TECHNICAL SERVICES INFORMATION BULLETIN

TSIB 21-05, rev A		06/02/2021
TO:	All operators	
TITLE:	Coolant Hump Hose Replacement	
APPLICABILITY:	Model Year 2017-2021 J4500 coach model: 67759 - 69938 Model Year 2019-2021 J3500 coach model: 21000 - 21085 Model Year 2017-2020 D4X0X coach model: 14197 – 15920 Model Year 2019-2021 D45CRT-LE coach model: 81000 – 81099 Model Year 2020 D4520 coach model: 81084, 81085

This bulletin is to inform of part number supersession of the coolant hump hose, MCI P/N: 6L-8-353, to 06-08-2262. Detailed location of the hose(s) for each coach model and engine configuration is shown below.

4.2 Coaches equipped with ISX engine

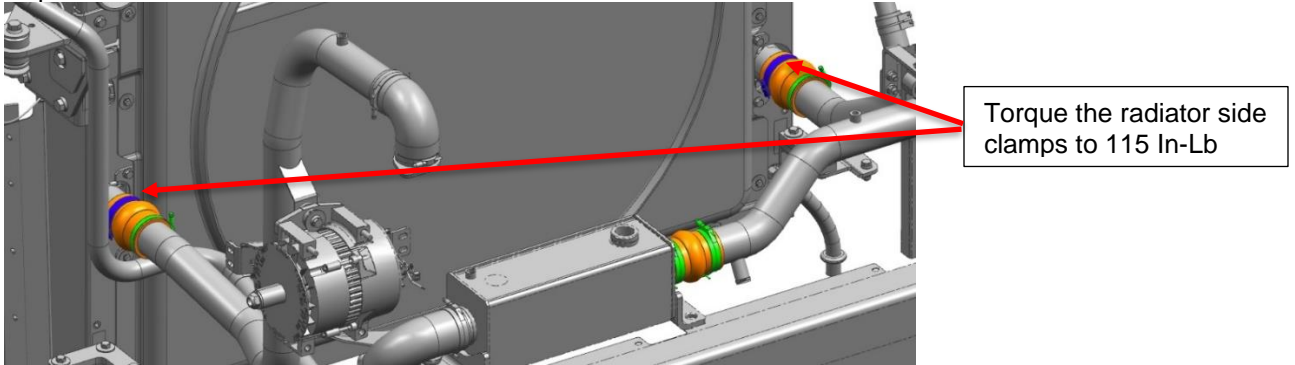
Replace the two hoses connected to the radiator and the hose connected to the trans cooler.

After installing the new hose, torque the two radiator side clamps to 115 In-Lb and the remaining six clamps to 13 In-Lb

4.3 Coaches equipped with DD13 engine

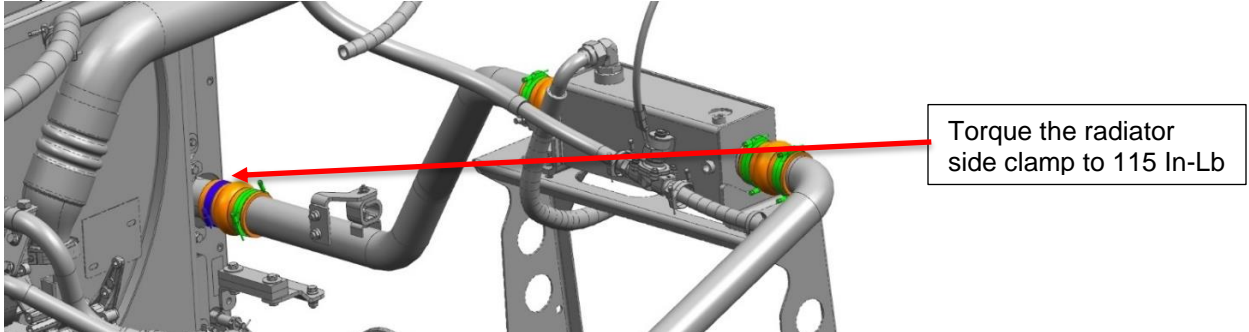
Replace the two hoses connected to the trans cooler and the hose connected to the radiator.

After installing the new hose, torque the one clamp on the radiator to 115 In-Lb and the remaining ten clamps to 13 In-Lb.

5.2 Coaches equipped with ISX engine

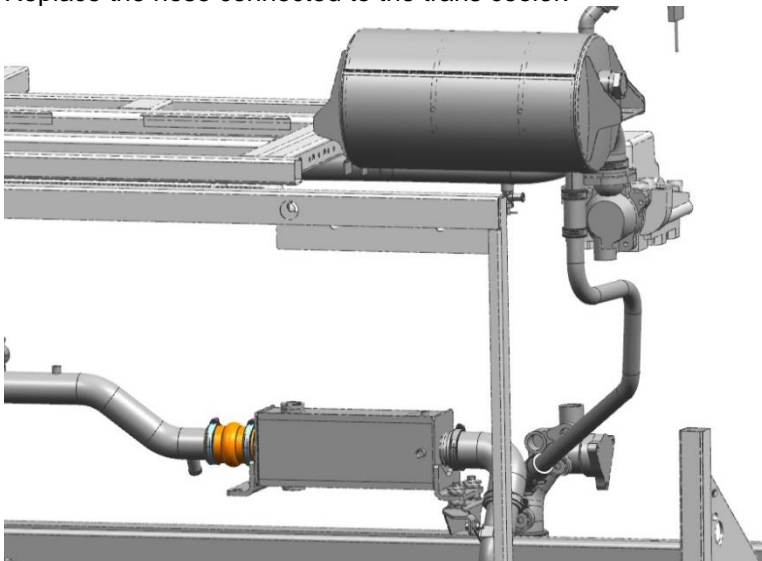
Replace the hose connected to the trans cooler.

After installing the new hose, torque the clamps to 105 In-Lb.

5.3 Coaches equipped with DD13 engine

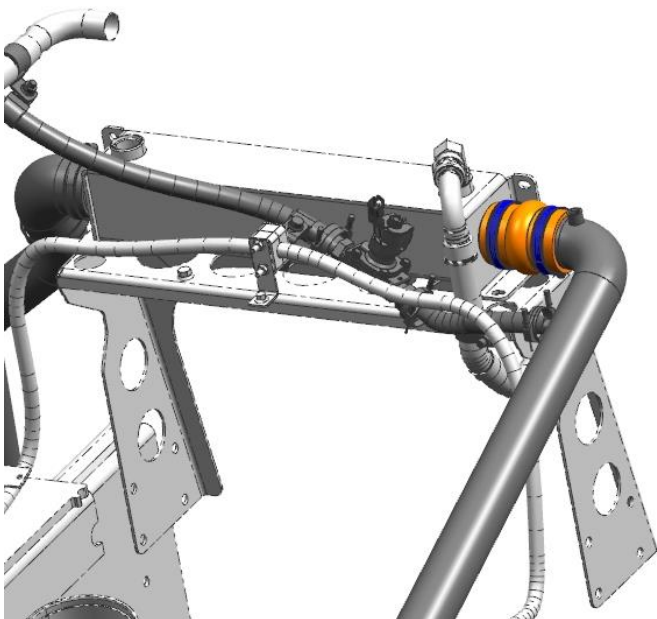
Replace the hose connected to the trans cooler.

After installing the new hose, torque the clamps to 105 In-Lb.

6.2 Coaches equipped with ISX engine

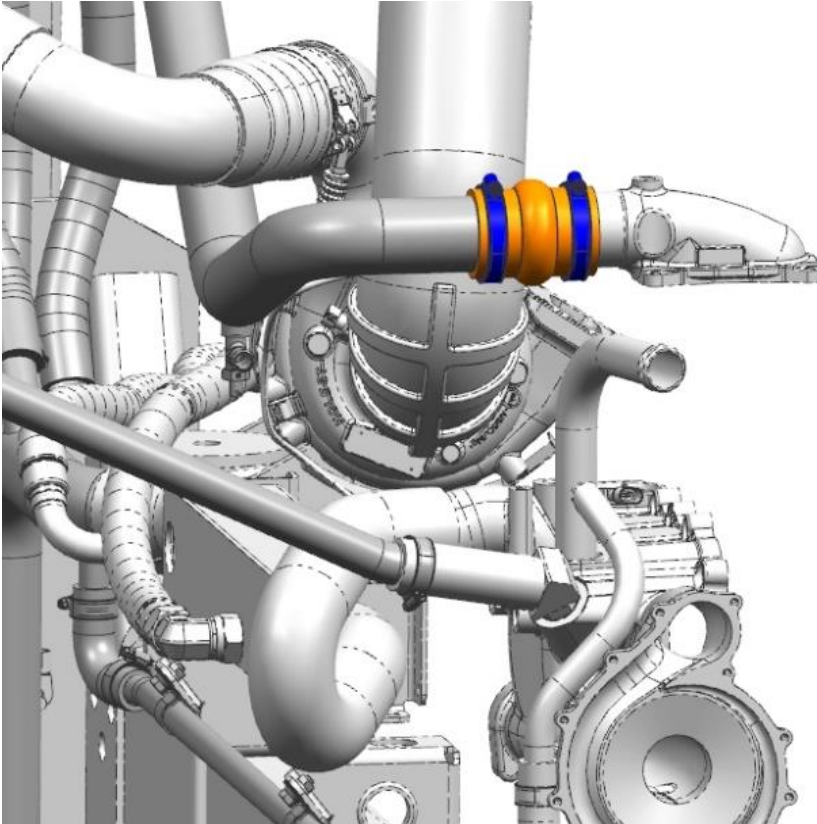
Replace the hose connected to coolant pipe.

After installing the new hose, torque the clamps to 105 In-Lb.

7.2 Hose replacement

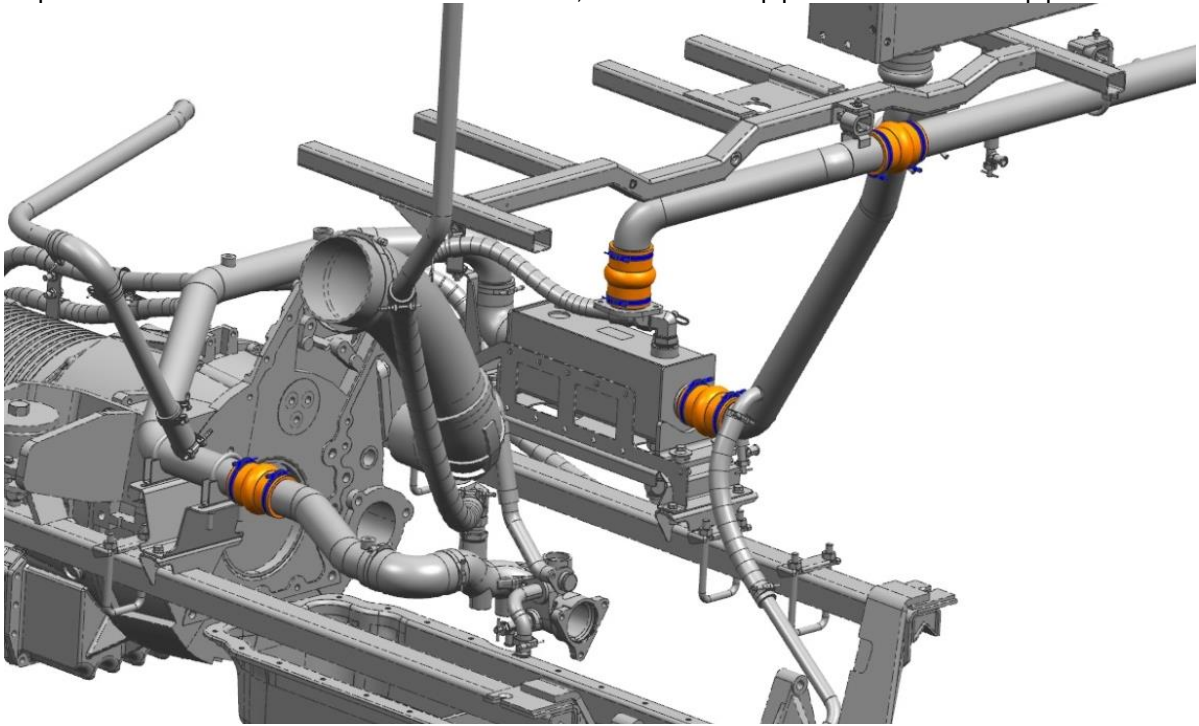
Replace the hoses connected to the trans cooler, coolant return pipe and radiator inlet pipes.

After installing the new hose, torque the clamps to 13 In-Lb

8.2 Hose replacement

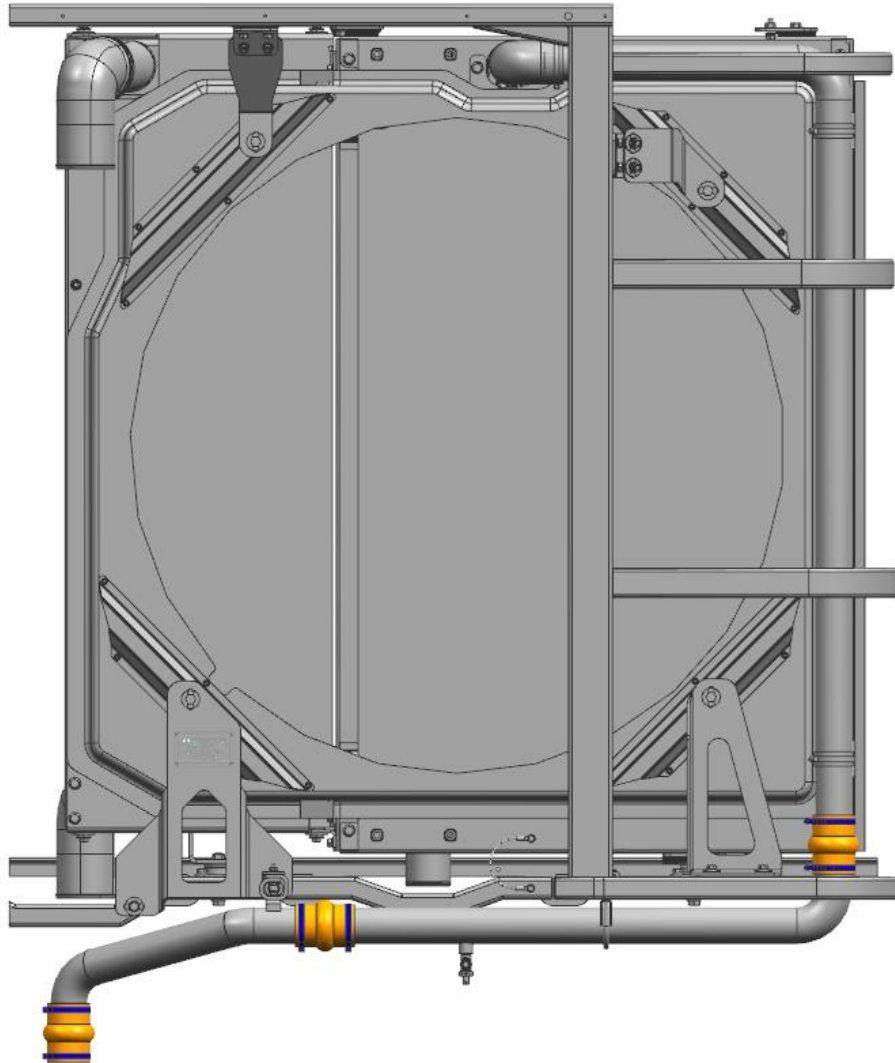
Replace the hoses connected to the radiator inlet pipes.

After installing the new hose, torque the clamps to 13 In-Lb

9.2 Hose replacement

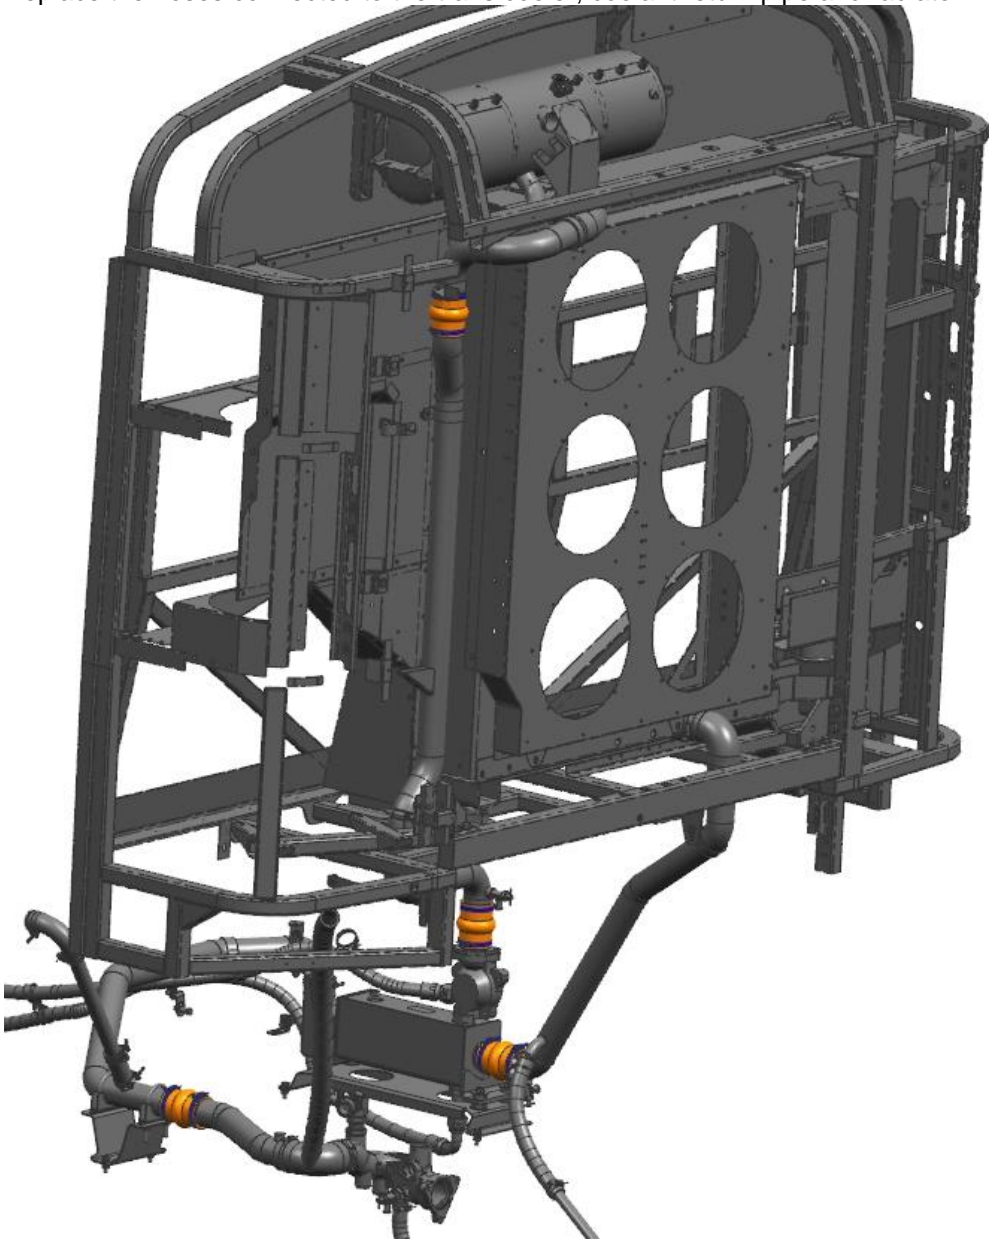
Replace the hoses connected to the trans cooler, coolant return pipe and radiator inlet pipes.

After installing the new hose, torque the clamps to 13 In-Lb

10.2 Hose replacement

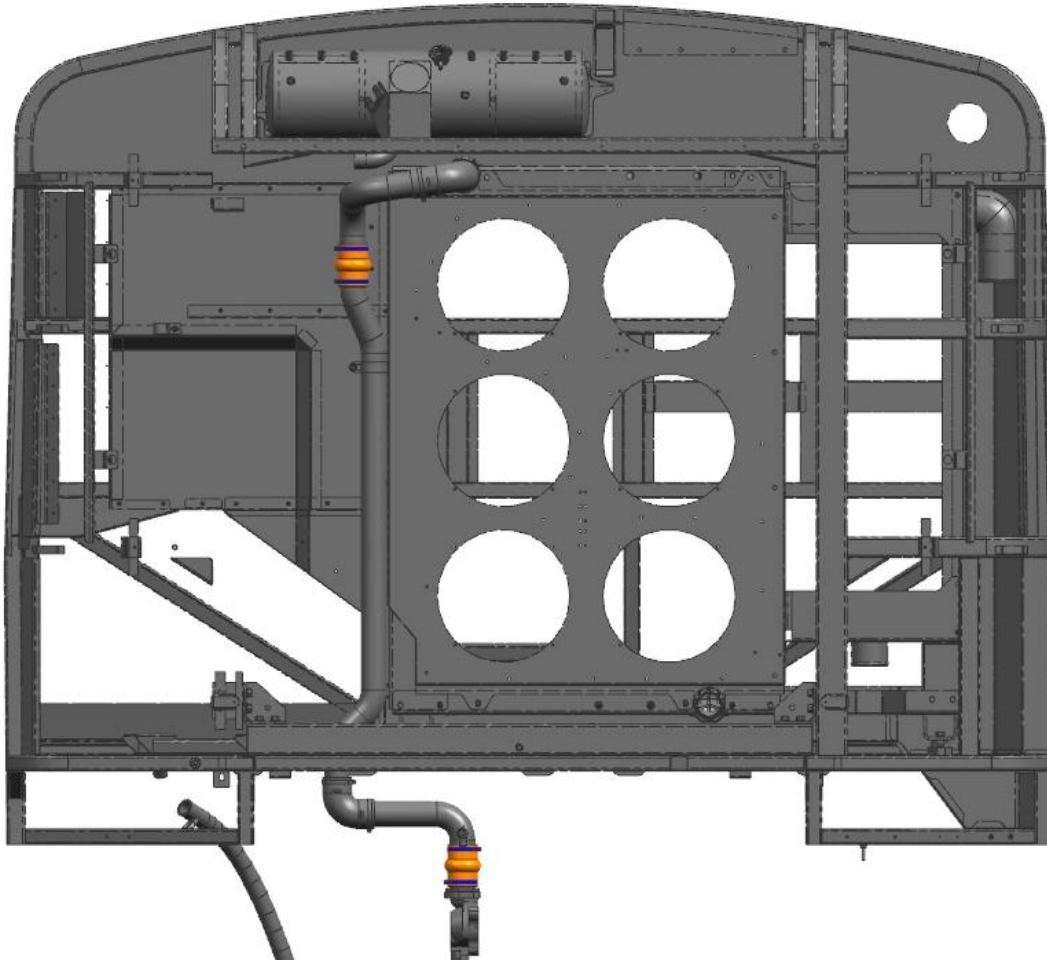
Replace the hoses connected to the radiator inlet pipes.

After installing the new hose, torque the clamps to 13 In-Lb.
